Change in Wafer Fabrication Facility for XC95144XL and XC9572XL CPLDs

XC�05003 (v1.0) January 31, 2005

Product/Process Change Notice

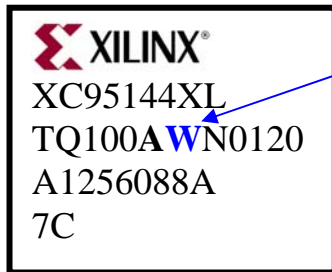
These devices can be distinguished by the second letter in the 3-letter code located in the middle of the second line of the package topmark. The 2nd letter is “W” for product fabricated at He Jian, and ‘M’ for product fabricated at UMC. Please reference the diagram below.

Fab Code:

M = UMC, Taiwan

W = He Jian, China
